SINGULARITY ENTERPRISES

Technical
Service
Bulletin

Professional Audio Service Bulletin

- SUBJECT: Modification of Record Logic
- APPLICABLE TO: All M79 Multi-Track Recorders
- PURPOSE: To allow Record punch-in by pressing only the Record and punch-out by pressing the Play button.

FIGURE 6

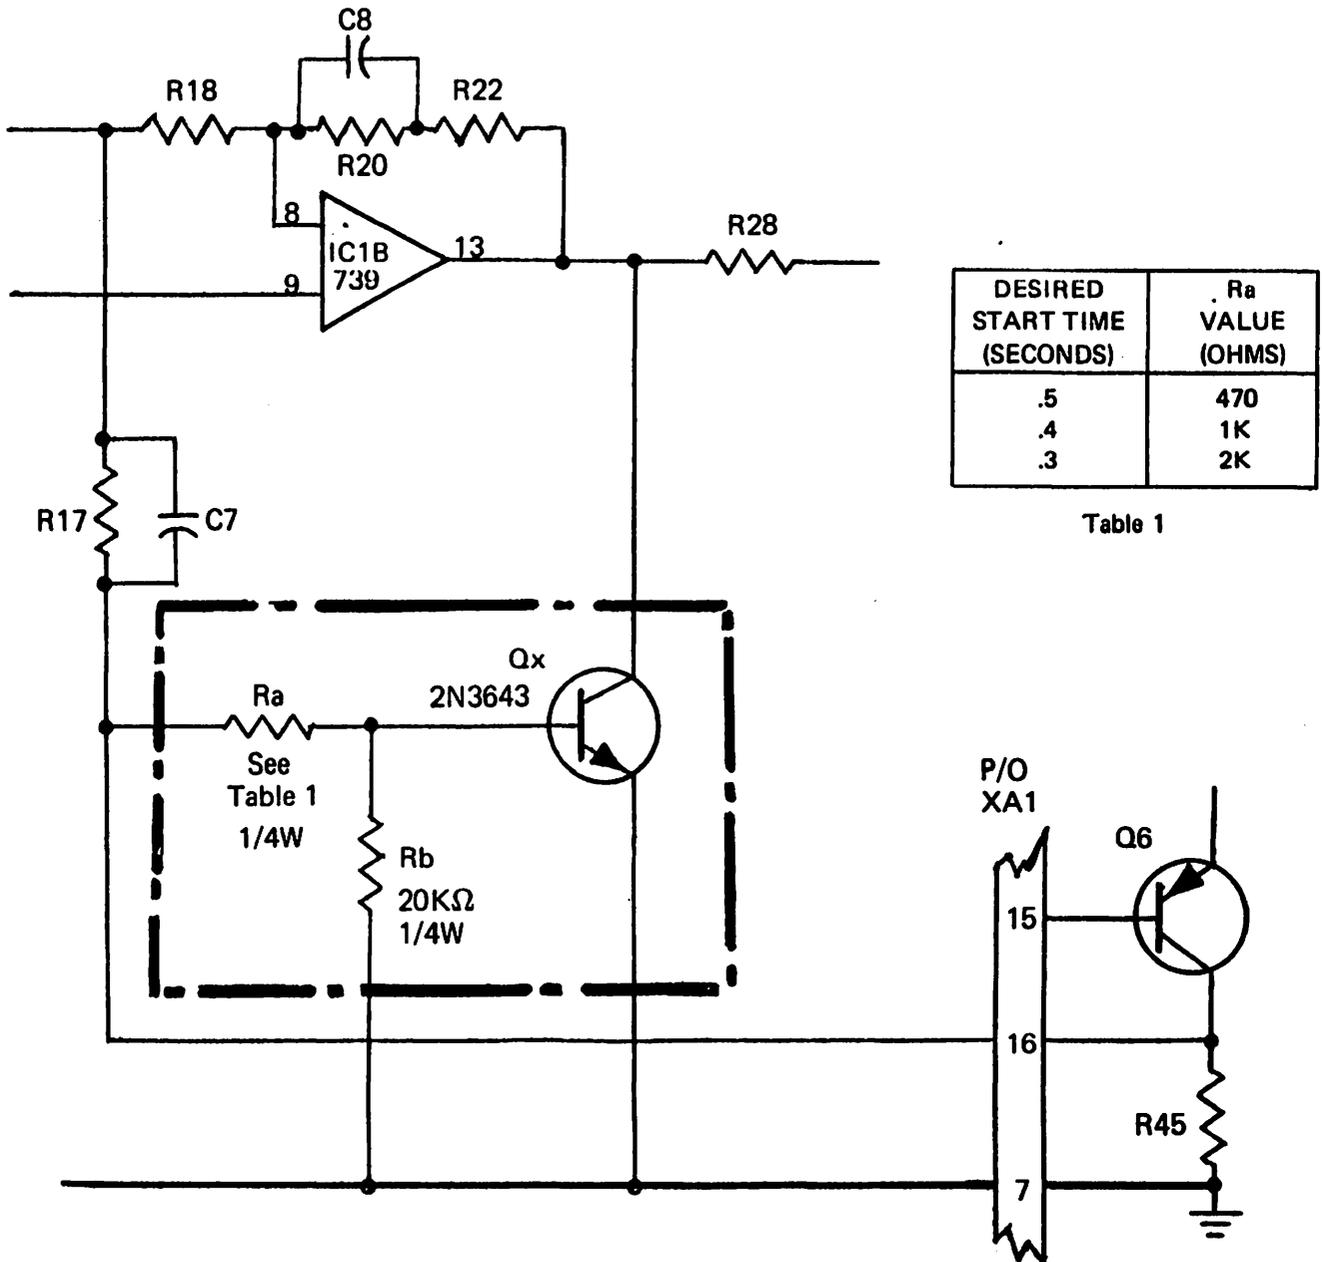
7. Modify Capstan Servo p.c. board (see figure 6).
 - a. Connect resistor Rb between GROUND and the base of Transistor Qx.
 - b. Connect resistor Ra between the junction of R17 and C7 (junction nearest to p.c. board side) and the junction of Rb and Qx base.
 - c. Connect the emitter of Qx to ground.
 - d. Connect the collector of Qx to the junction of R28 and IC1B pin 13.
8. Adjust capstan servo p.c. board pulse width and speed if necessary.
9. Perform reel alignment procedure.

FIGURE 1

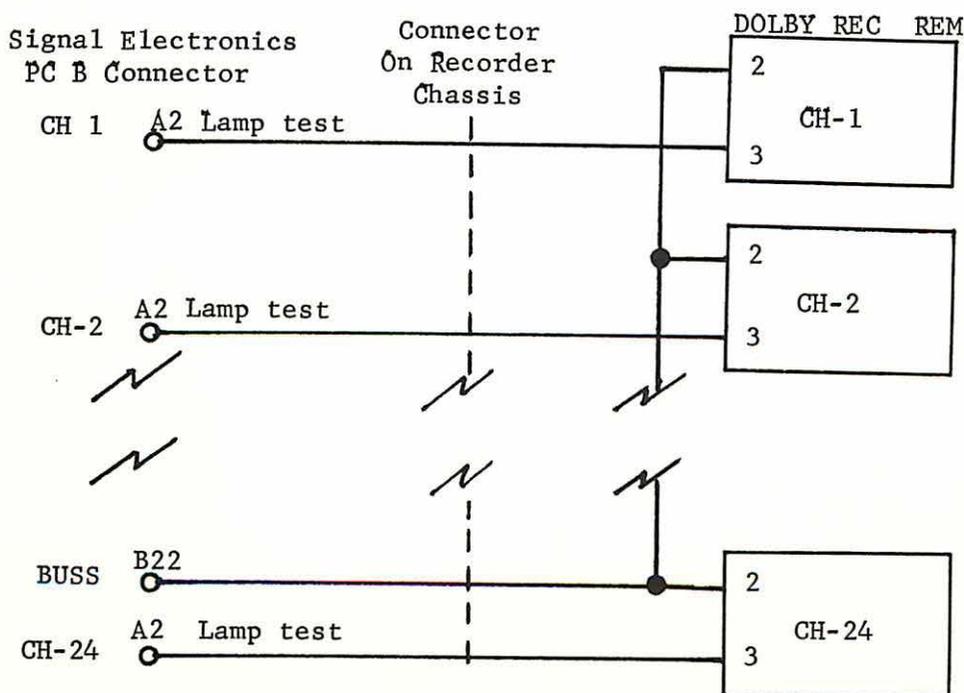
Remote connection of M series DOLBY units to M-79 (see figure 1).

1. Connect pin A-2 of each channel signal electronics pc board to pin 3 of the DOLBY unit through a suitable connector on the recorder chassis.
2. Connect pin B-22 bus on signal electronic pc board pin 2 of ALL DOLBY units.
3. Insure R102 and R108 in CAT 44 Interface Module are 6.8 K ohms (earlier models had 2.7 K ohm or 3.3 K ohm resistors); if the resistors are not the correct values, replace them with resistors of the correct value.

FIGURE 2

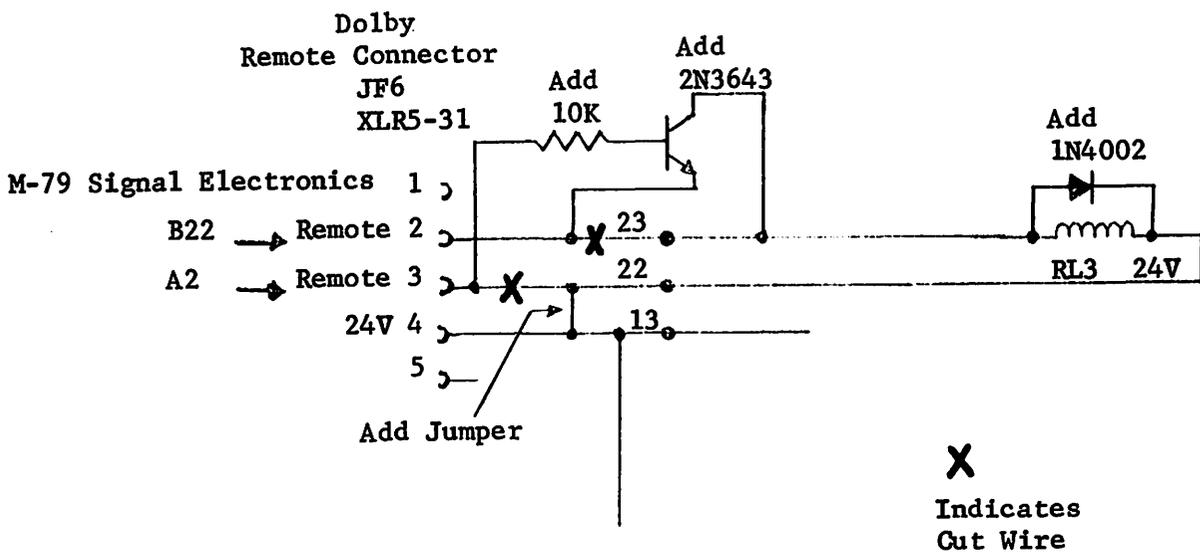
1. Connect Pin A2 of each M-79 Signal Electronics PC Board to Pin 3 of the DOLBY Remote Connector through a suitable connector on the recorder chassis.
2. Connect Pin B-22 buss on the M-79 Signal Electronics PC Boards to Pin 2 of ALL DOLBY units.
3. Modify DOLBY interface by adding circuit as shown in Figure 2.
NOTE: Refer to DOLBY 361 Interface circuit in the DOLBY Manual.

FIGURE 1

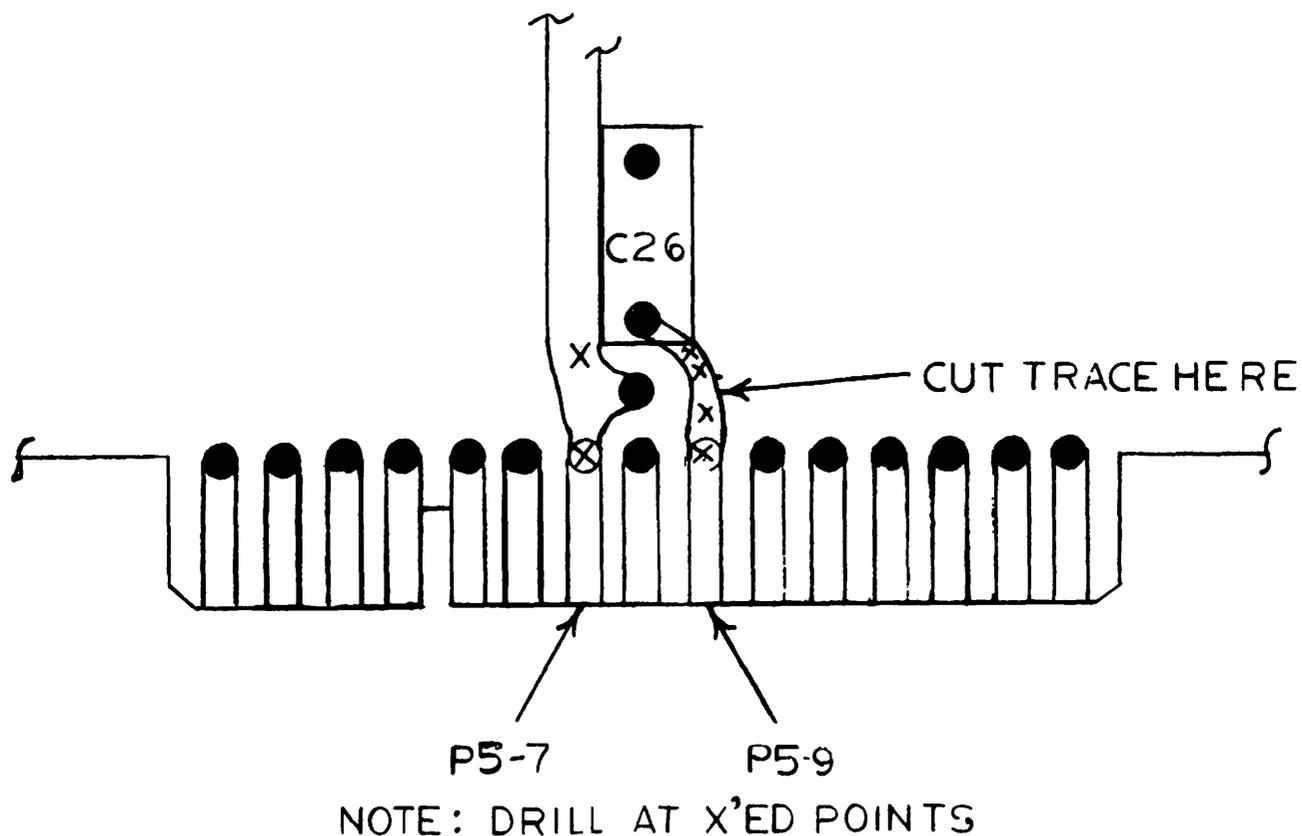
- V. Utilizing the drill motor and the #70 twist drill, put 6 holes thru the PC Board. Location of these holes are as follows: (See Figure I)
- A. Top of Contact Finger #9
 - B. Top of contact Finger #7
 - C. Between contact Finger #9 and cut in trace.
 - D. In trace running to the left of C-26 near lower left hand edge of C-26.
 - E. Between cut in trace and bottom of C-26, drill 2

FIGURE 2

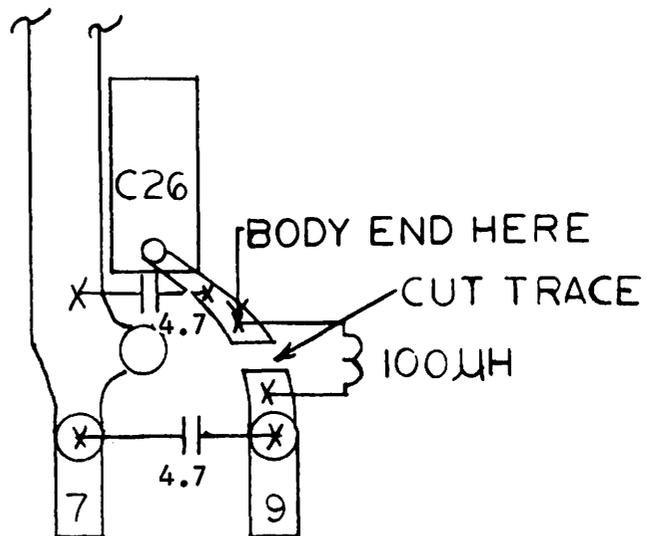
- VI. Install 4.7uf capacitor between holes drilled at top of contacts 7 & 9.
(See Figure 2)
- VII. Install 4.7uf capacitor between holes drilled just below and to the left and right of C-26. (See Figure #2)
- VIII. Install 100μh coil in two remaining holes (See Figure 2)

FIGURE 1

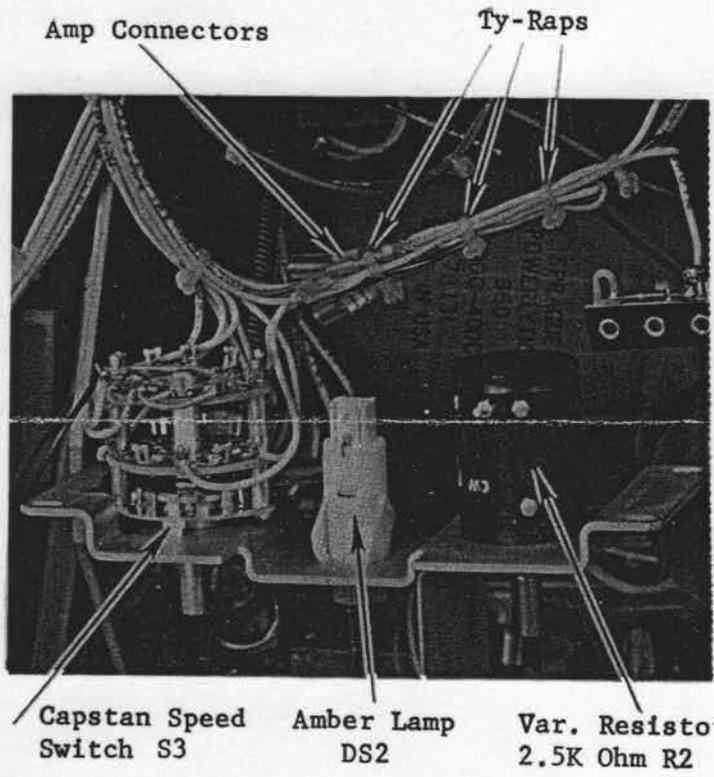
- 5) Remove the four Phillips Screws that hold the Capstan Speed Switch Assembly to the deck. This allows the Switch Assembly to drop back far enough to replace the Stripper plate. See Figure 1.

FIGURE 2

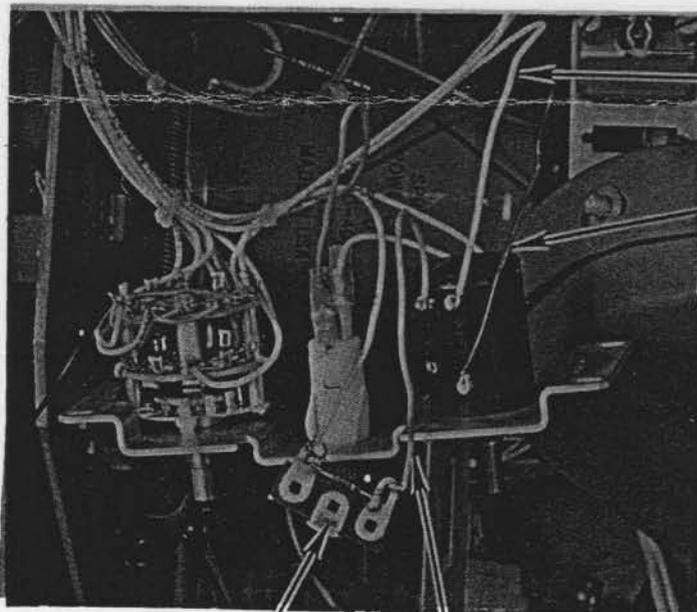
- 6) Mount Amber Lamp and 2.5 K ohm Variable Resistor. See Figure 2
- 7) Remove Ty-raps that secure wires with the Amp Connectors and connect to Amber Lamp. See Figure 2 and 3.

FIGURE 1

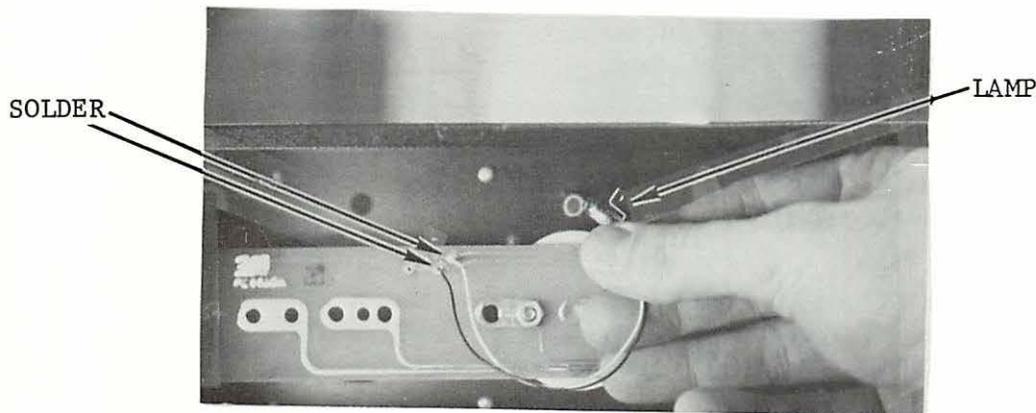
- I. Remove MURA type meter lamp from the white line cap above the meter and unplug the wires from meter mother board.
- II. Solder wires on lamp holder 83-1620-0294 in place of the removed wires on the mother board (see Figure 1).
